Middle Avenue Pedestrian & Bicycle Rail Crossing Study

Summary of Community Meeting #2

May 13, 2019

Photo 2 - Concept 1 Plan

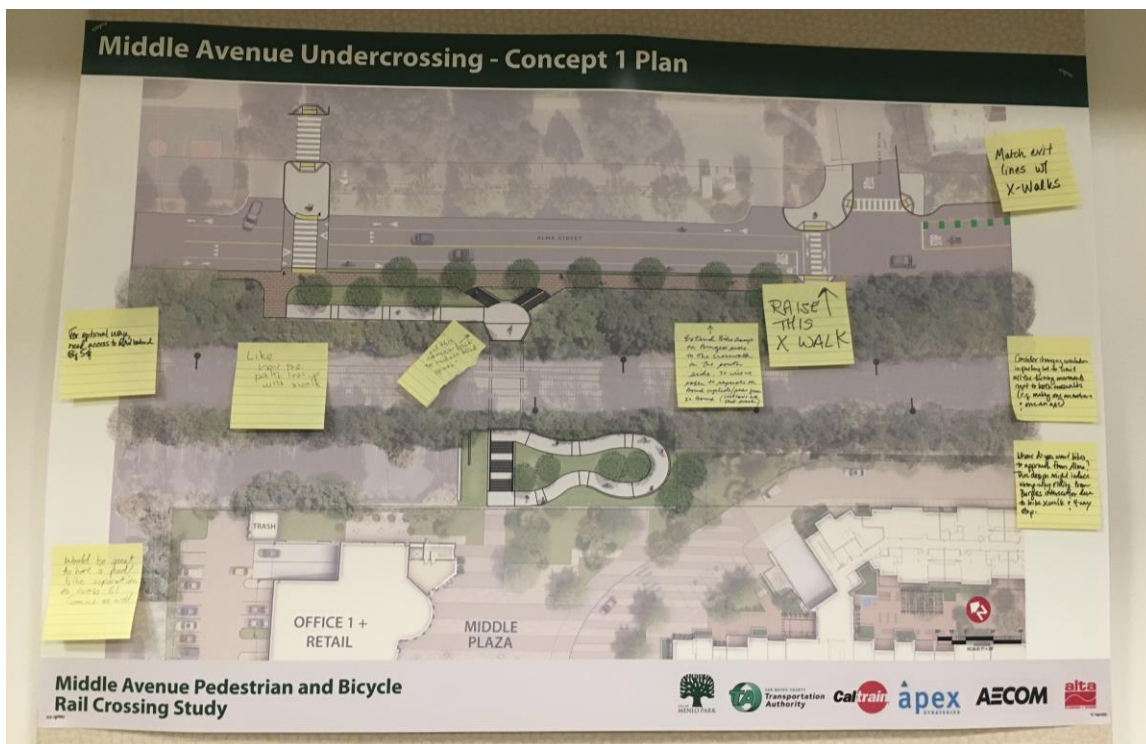
Exhibit Board	Comment/Feedback
Concept 1 Plan (Photo 2)	<ol style="list-style-type: none"> 1) Match exit lines with crosswalks 2) Raise this crosswalk 3) Consider changing circulation in parking lot to limit all the turning movements next to both crosswalks (e.g. making one an entrance and the other an exit) 4) Where do you want bikes to approach from Alma? This design might induce wrong-way riding from Burgess intersection due to bike crosswalk and 4-way stop 5) Add an external bike ramp on Burgess side to the crosswalk on the south side, it will be safer to separate northbound cyclists/pedestrians from southbound side (cost can't be that much) 6) Pull this ramp corner back to reduce blind spots 7) Like how the path lines up with the crosswalk on the left side 8) For optimal usage, need access to R/W behind Big 5? 9) Would be great to have a ped/bike separation to cross El Camino as well
Concept 1 Elevations (Photo 3)	<ol style="list-style-type: none"> 10) Need stair/bike channel to carry bike up the stairs 11) Provide ramps to side of stairs

Photo 5 – Concept 1 3D Renderings

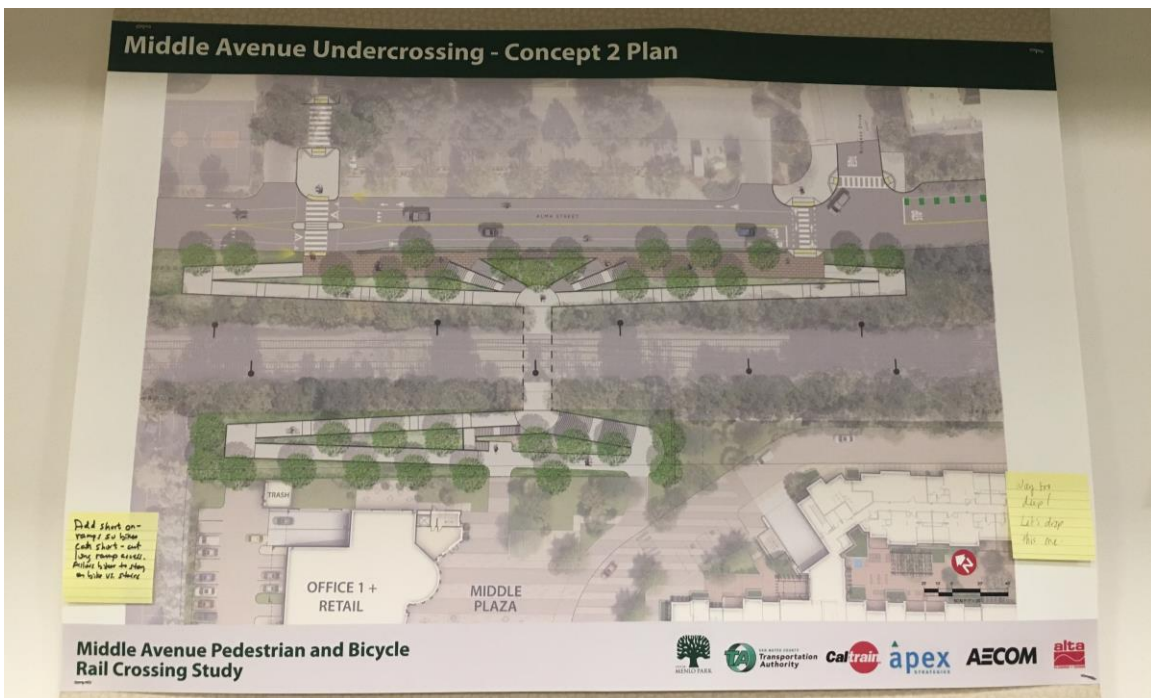
<p>to walk bike up – stair channel</p> <p>12) For concept 3, maybe just put the bike ramp on one side, like with concept 1</p>
Concept 1 – 3D Renderings (Photo 4)	<p>13) Need access point on Middle Plaza</p> <p>14) This merge is a collision area, it needs something</p>
Concept 1 – 3D Renderings (Photo 5)	<p>15) Please do not wait for grade separation 10+ years</p>
Concept 2 Plan (Photo 6)	<p>16) Way too deep! Let's drop this one</p> <p>17) Add short on-ramps so bikes can shortcut long ramp access. Allows bicyclists to stay on bike vs stairs</p>
Concept 2 Elevations (Photo 7)	<p>18) Too deep</p>
Concept 3 – 3D Renderings (Photo 8)	<p>19) Lower the wall and remove blind corner</p>
